| ADDENDUM NO. 3 - TO THE DRAWINGS AND PROJECT MANUAL FOR BECK CHEVROLET BUICK GMC Facility Image Renovations 1601 Reid Street, Palatka, Florida 32177 | | | | | | | | |

EXTRA THIN FLUSH MOUNTS

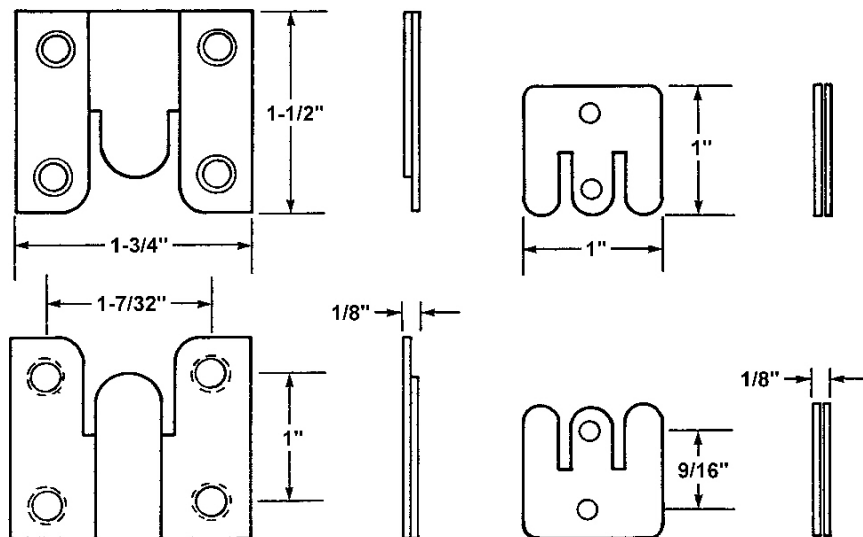
| ADDENDUM NO. 3 - TO THE DRAWINGS AND PROJECT MANUAL FOR BECK CHEVROLET BUICK GMC Facility Image Renovations 1601 Reid Street, Palatka, Florida 32177 | | | | | | | | |
|---|---------|------------------|---------------|---------------------|--|---|---|--------------------|
| 1 | 6 | A5-1 | | Concealed Fasteners | Describe the installation of the MDF panels covered with a wall covering as shown on elev.3 on A5-1. Are concealed fasteners used? If so, please spec. Are the panels attached with exposed s.s.screws and button type washers to blocking in the wall framing? Or, are the MDF panels attached and wall covering applied after they are in place? | Use http://www.rockler.com - EXTRA THIN FLUSH MOUNTS or equivalent, see attached product data sheet. Mount panels with mounting hardware, use spots of mastic to secure permanently. Route back of panel as necessary to accommodate depth of mounting hardware. This item shall be added to 06402, 2.3, as item K. | SECTION 06402_3-1-E_Flush_Mounts_Addendum_2.pdf | 6402 |
